**CITY OF MERIDIAN
FINDINGS OF FACT, CONCLUSIONS OF LAW
AND DECISION & ORDER**

Case No(s). H-2023-0021

STAFF REPORT	
COMMUNITY DEVELOPMENT DEPARTMENT

SUBJECT: Driftwood Subdivision – CUP, PFP
[H-2023-0021](#)

A. Site Plan (dated: 4/20/23)

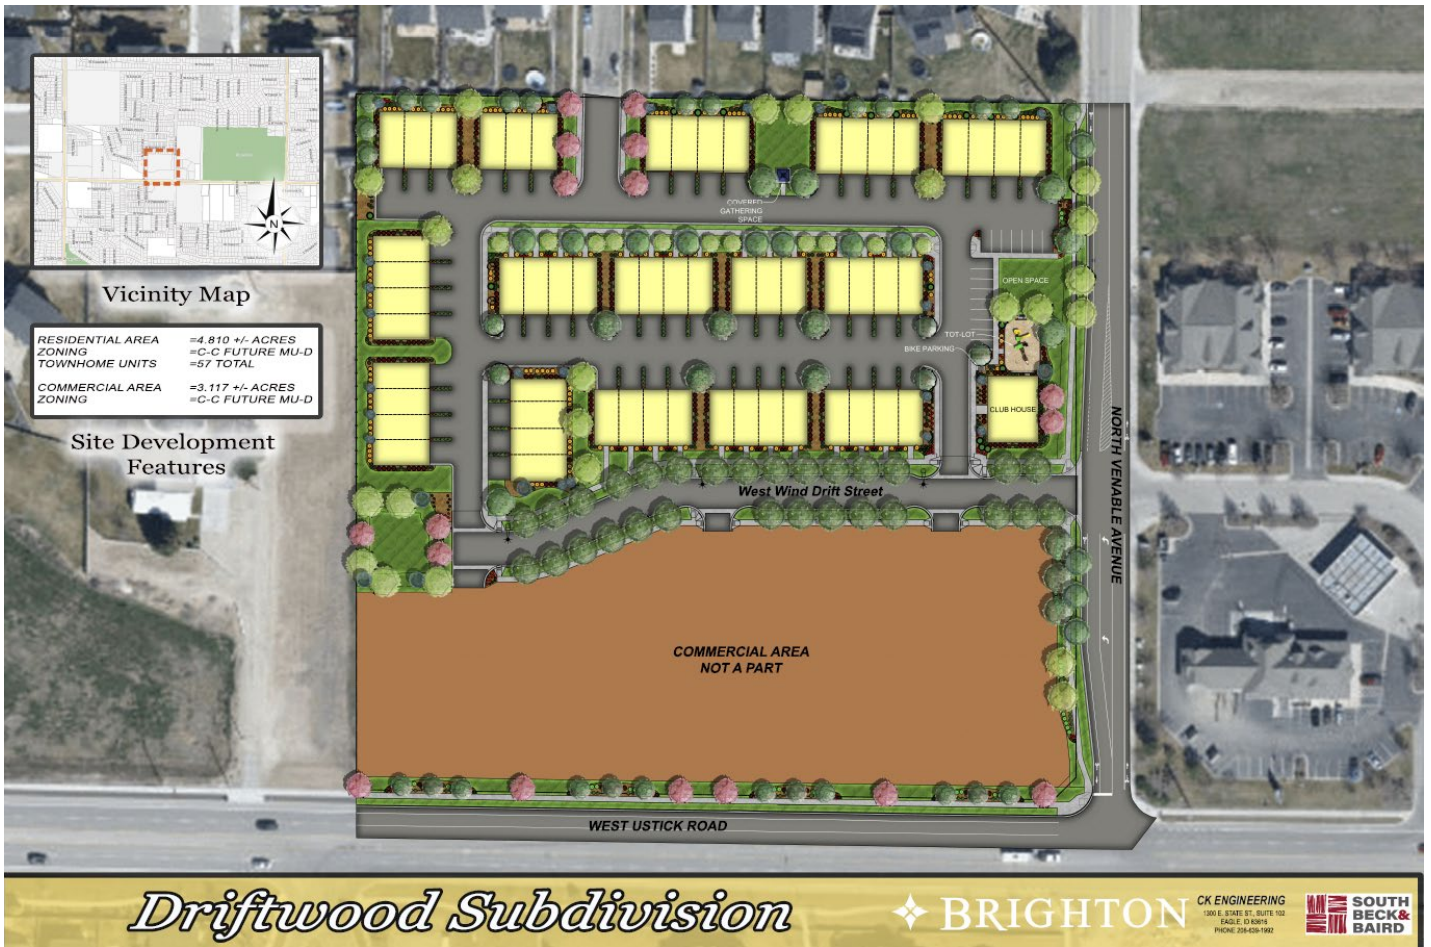
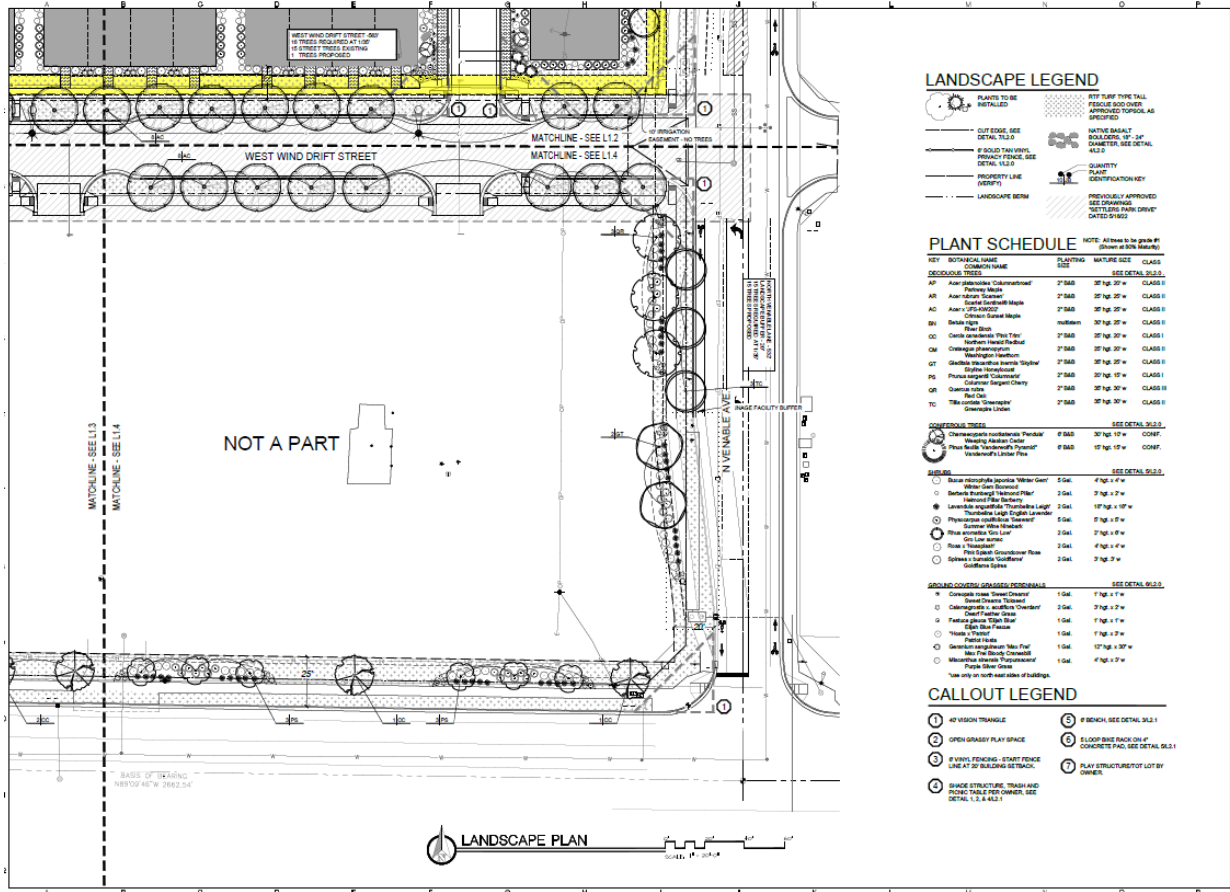
uses must be setback a minimum of 25 feet from the property line. The plans should be revised to reflect compliance with this standard.

2. All on-site service areas, outdoor storage areas, waste storage, disposal facilities, and transformer and utility vaults shall be located in an area not visible from a public street, or shall be fully screened from view from a public street. ***All proposed transformer/utility vaults and other service areas shall comply with this requirement. A trash dumpster/enclosure should be depicted on the site plan and should accommodate recycling.***

A 25-foot wide buffer is required to adjoining residential uses in the C-C zoning district, per UDC Table 11-2B-3 as shown on the site plan; the landscape plan incorrectly depicts a 15-foot wide buffer which should be revised. Landscaping is required to be installed within the buffer in accord with the standards listed in UDC [11-3B-9C](#). All buffer areas are required to be comprised of, but not limited to, a mix of evergreen and deciduous trees, shrubs, lawn, or other vegetative ground cover that results in a barrier that allows trees to touch within five (5) years of planting. Trees that will not touch until maturity outside of this timeframe must be supplemented with additional

B. Landscape Plan (dated: 2/28/23) & Open Space and Amenity Details

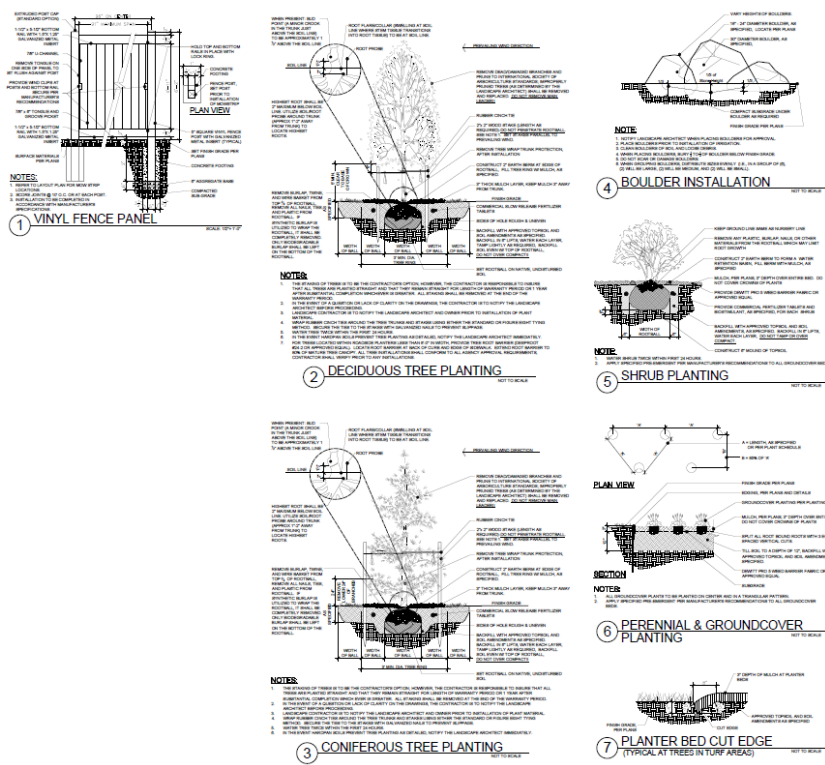
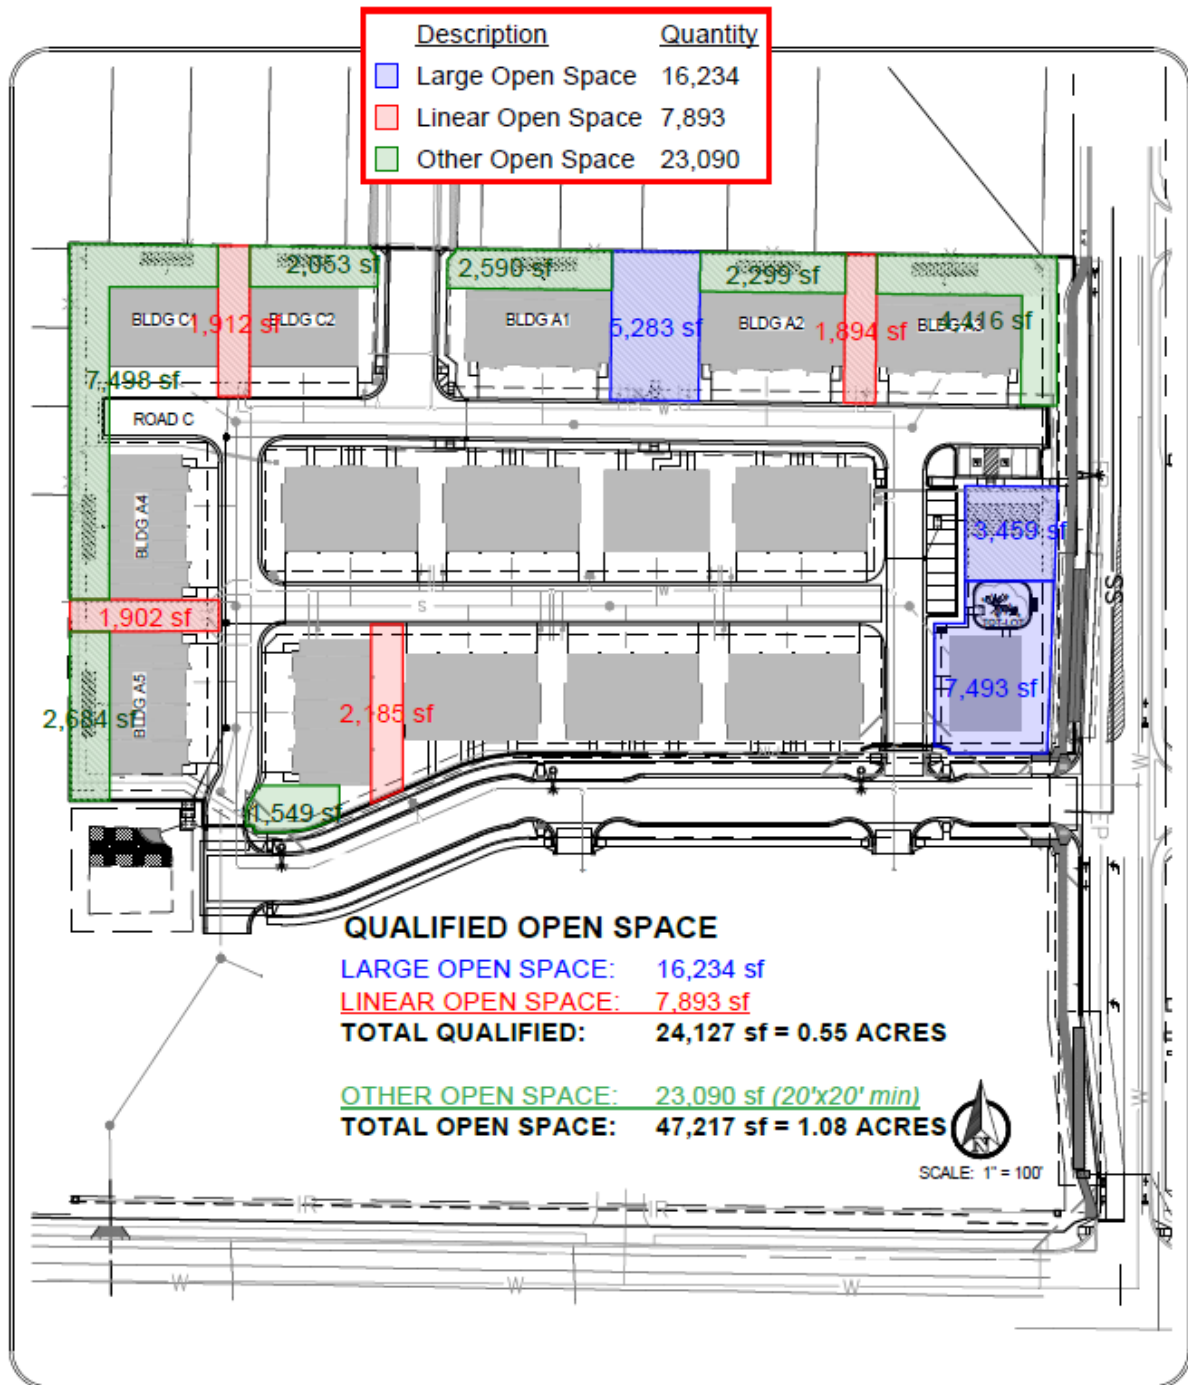
- E. Landscaping Requirements: Development shall meet the minimum landscaping requirements in accord with chapter 3, "Regulations Applying to All Districts", of this title. Additionally, all street facing elevations shall have landscaping along their foundation that complies with the standards listed in UDC [11-4-3-27E.2](#), which requires a landscape area at least 3-feet wide planted with one evergreen shrub every three (3) linear feet that has a mature height of 24-inches with ground cover plants in the remainder of the landscaped area. ***The landscape plan submitted with the Certificate of Zoning Compliance application should be revised to include evergreen shrubs in accord with this standard.***

Landscaping is required to be provided along all pathways per the standards listed in UDC [11-3B-12C](#), which require a mix of trees, shrubs, lawn, and/or other vegetative groundcover within 5-foot wide strips on each side of the pathway; depict landscaping per these standards along the east/west pathway adjacent to the drive aisle.

materials such as tall columnar evergreen shrubs, or other qualifying materials. A 10-foot wide public utilities, property drainage, and pressure irrigation easement is designated along the boundary of the subdivision, which prohibits trees within the easement – all trees should be planted outside of the easement area.

Landscaping (UDC [11-3B](#)): A 25-foot wide street buffer is required along W. Ustick Rd., an arterial street, and a 20-foot wide street buffer along N. Venable Ave., a collector street, as depicted on the landscape plan. **These buffers shall be depicted on the plat in common lots or dedicated buffer easements, maintained by the property owner, homeowner’s association or business owner’s association as set forth in UDC [11-3B-7C.2a](#).** The buffers should be measured from the back of curb per UDC 11-3B-7C.1a(2).

- a. Include a detail of the tot lot play equipment.
 - b. Depict landscaping within the street buffers along N. Venable Ave. and W. Ustick Rd. in accord with the standards listed in UDC [11-3B-7C](#).

- c. All landscaping except for street buffers should be removed from the plan or shown in a lighter line type as internal landscaping is not required with the subdivision improvements.

C. Conceptual Building Elevations

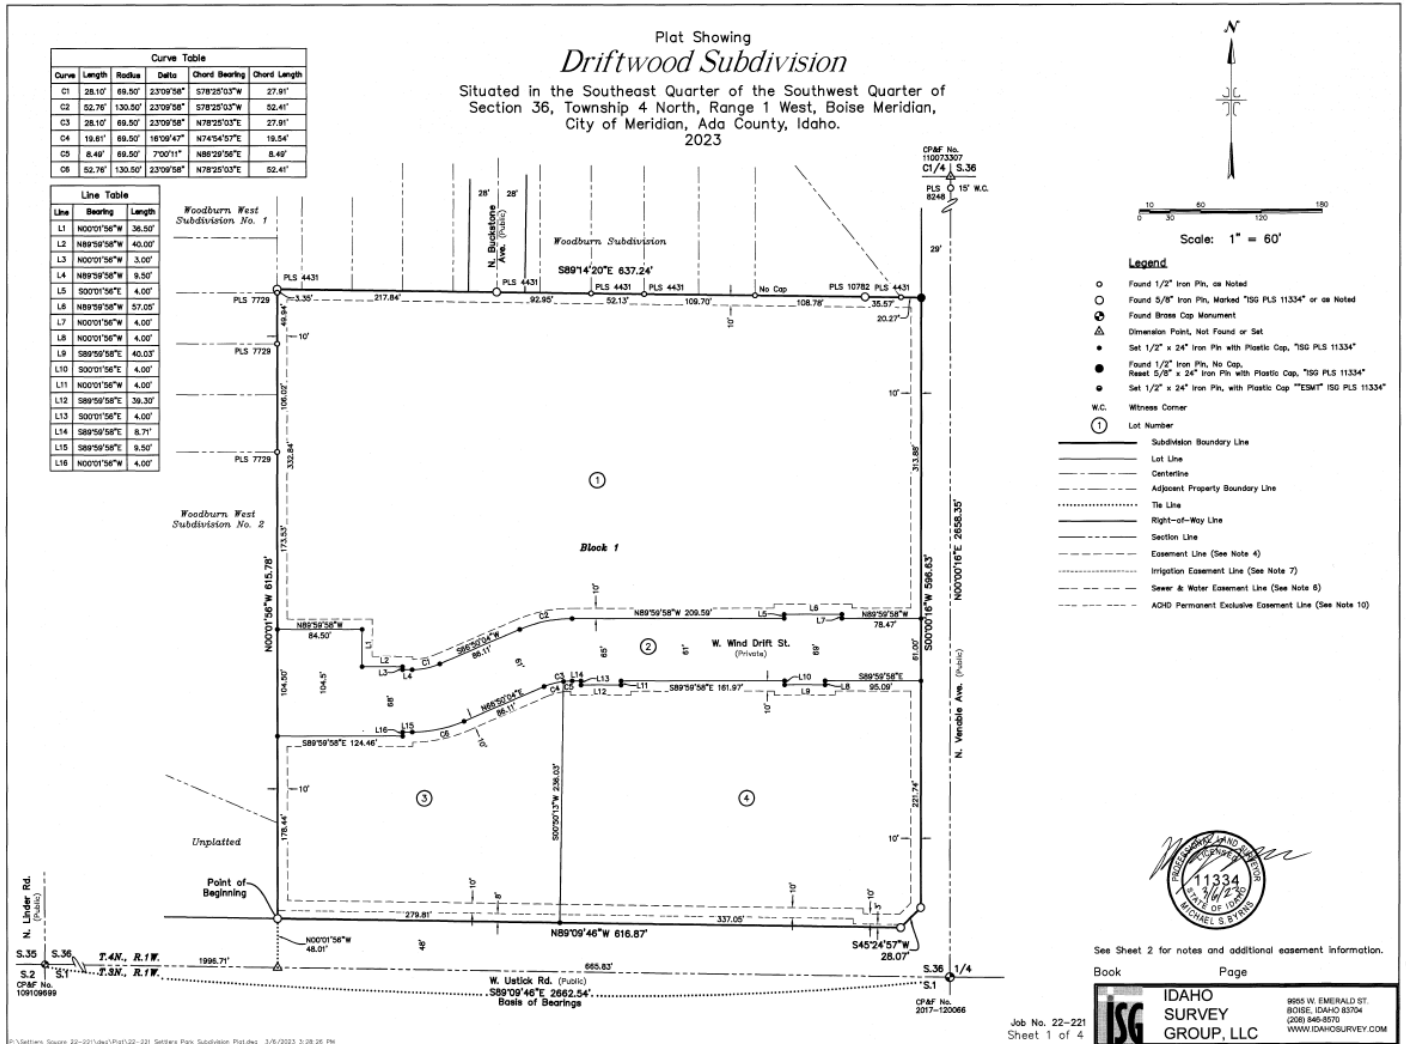
Building Elevations (UDC [11-3A-19](#) | [Architectural Standards Manual](#)): Conceptual building elevations were submitted for the 2-story alley-loaded and front-loaded townhome-style units and the clubhouse as shown in Section VIII.C below. Building materials appear to consist of stucco and horizontal siding in two (2) different colors with stone veneer accents. These elevations are generally consistent with those included in the existing Development Agreement (DA) as required.

Final design of all structures is required to comply with the design standards in the Architectural Standards Manual and will be reviewed for compliance with these standards with the Design Review application. **Compliance with the building code requirements for separation between structures within the development is required.**

D. Preliminary Plat (dated: 3/6/23)

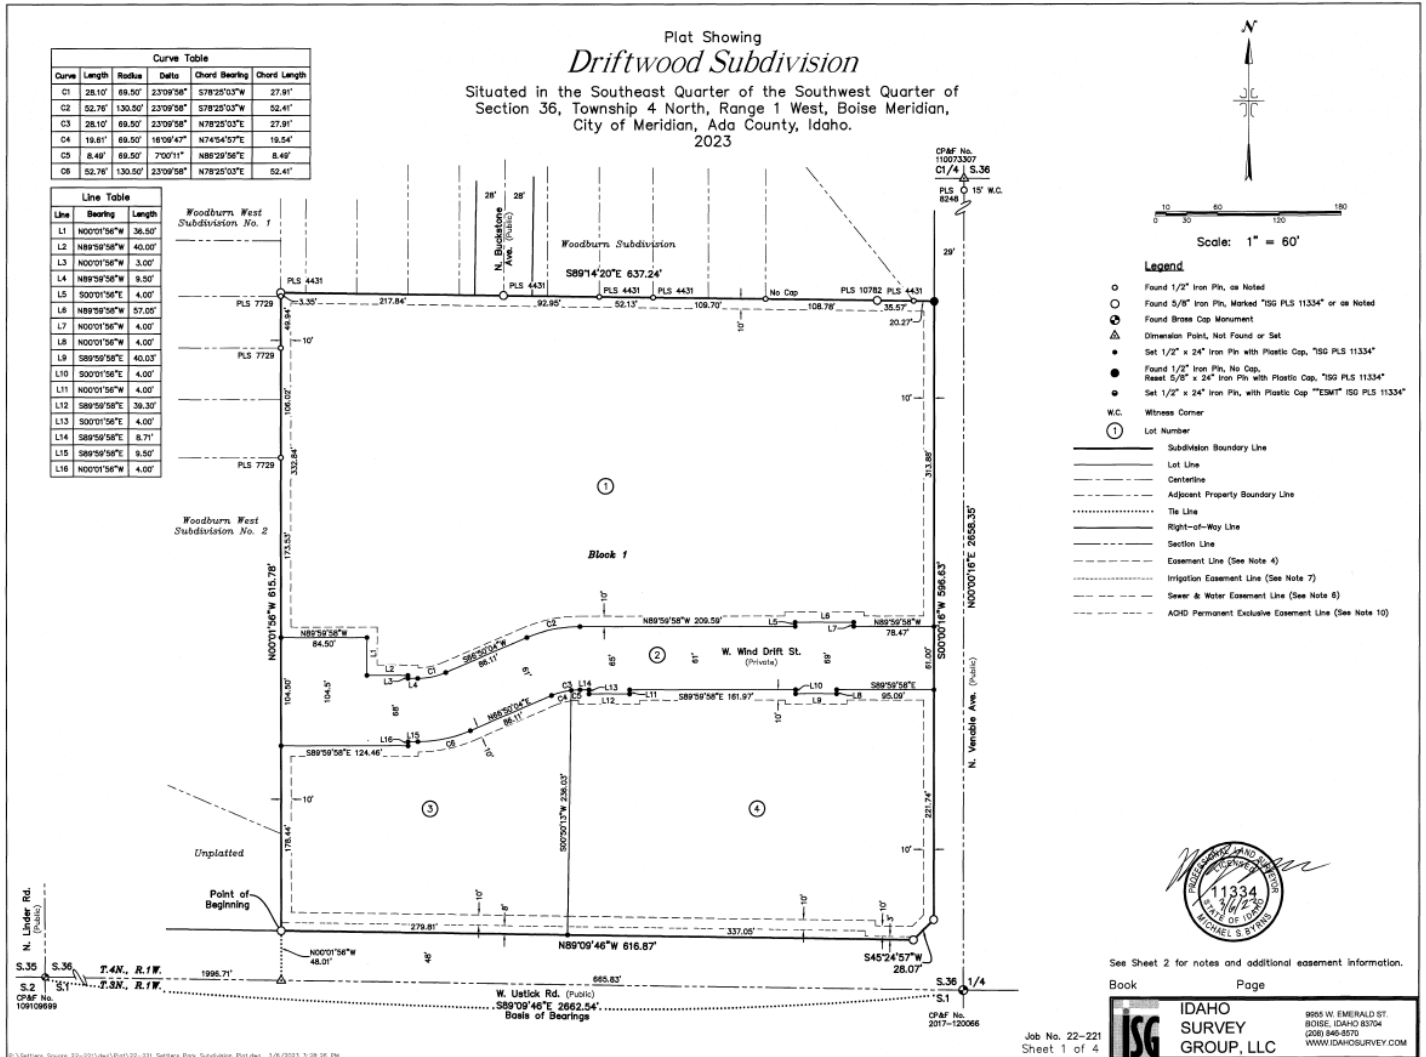
Access: Access is proposed via a driveway from N. Venable Ave., a collector street, at the east boundary and N. Buckstone Ave., a local street, at the north boundary. Buckstone currently stubs to the northern boundary of this site. An east/west drive aisle was previously approved with the site improvements (A-2022-0111) on Lot 2, Block 1. **The plat depicts a name for this access driveway, which should be removed as this road is a drive aisle and wasn’t approved as a public or private road. If the Applicant wishes to name this road, a private street application should be submitted.**

A cross-access easement is required to be granted to the property abutting the southwest property boundary (Parcel #S0436346613) as set forth in the existing Development Agreement. A copy of the recorded easement shall be submitted to the Planning Division prior to issuance of Certificate of Occupancy for the western commercial pad site OR when Parcel #S0436346613 developers, whichever occurs first.

- d. Note #4: Remove the street name (i.e. W. Wind Drift St.) as a private street was not approved. If the drive aisle is to be names, a private street application shall be submitted.

- e. Note #7: Include recorded instrument numbers of the Setter's Irrigation District pressure irrigation easement.
3. The landscape plan submitted with the final plat for City Engineer signature shall include the following revisions:
